Application for "Other Business" Cobb County, Georgia

OB-24

Other Business Application of Pebblebrook Development, LLC regarding the Rezoning Application of Talley Development (No. Z-61 [2006])

Application of Talley Development to Rezone a 12.43 Acre Tract from R-20 to

AFFLICANI: 1a	Illey Development	PETITION NO:	Z-61
770	0-760-9376	HEARING DATE (PC):	05-02-06
REPRESENTATIV	E: Roy L. Talley, Jr.	HEARING DATE (BOC):	05-16-06

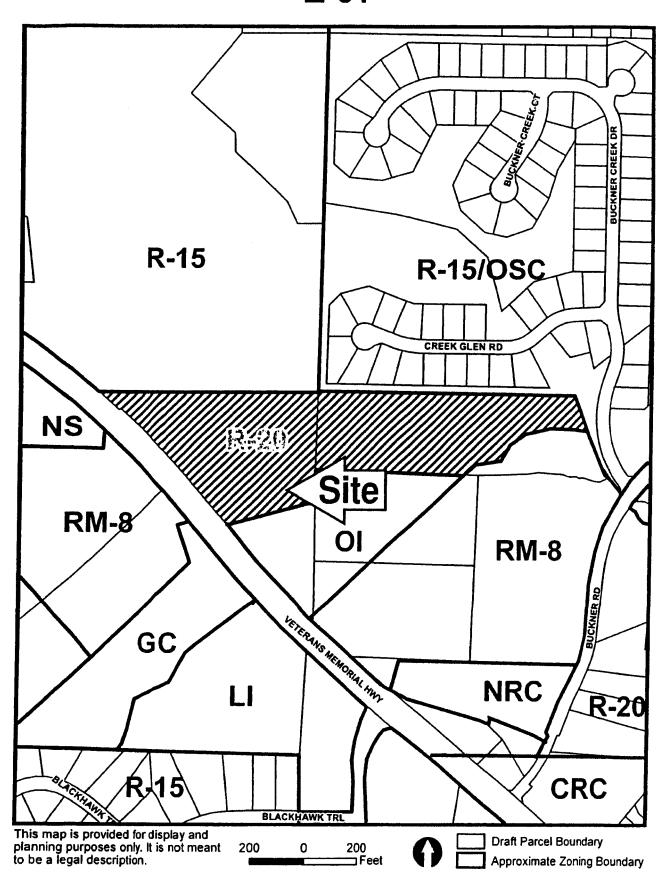
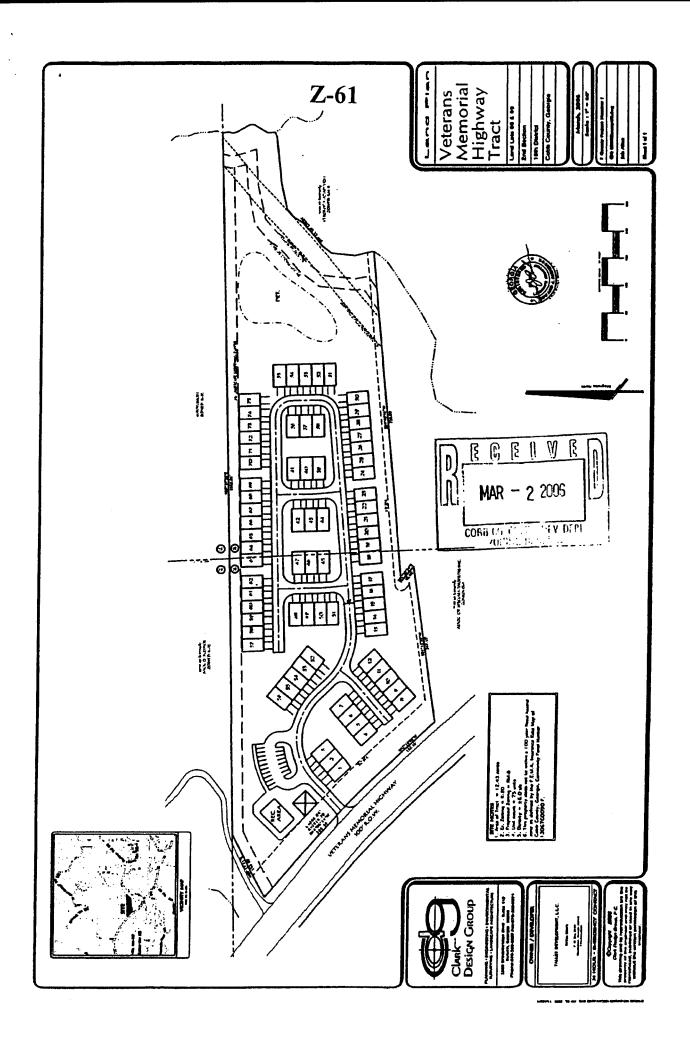
- 1. The site is located on a fairly heavily wooded site with slopes from 10 20%. The proposed RM-8 attached condominium units are not well suited for the terrain on this site and will result in significant grading.

- 2. The extensive existing tree stand and undergrowth provide significant air/water quality, soil stabilization and storm flow mitigation benefits for this watershed. Construction of this project will eliminate the vast majority of this vegetation and increase pavement, storm runoff and non-point source pollution. To compensate, the First Flush Water Quality Best Management Practice Requirements must be elevated to the 1.5-inch rainfall event and each larger storm discharge controlled not to exceed the allowable discharge of the next lower, more frequent storm event (ie. 5year storm event released at 2-year rate; 10-year event at 5-year rate; etc. to 100-year event at 50-year

- 3. There is the potential for significant bypass of developed runoff across the southern property boundary. Runoff from the rear of Units 8 - 30 must be directed to flow to the proposed detention pond.

- 4. Contrary to Site Note #6, this project does lie within a 100-year flood hazard area as identified on the effective FEMA FIRM map. A detailed flood study will be required to determine the 100-year flood elevations along the stream at the rear of the property to verify that that detention pond is located out of the flood zone.
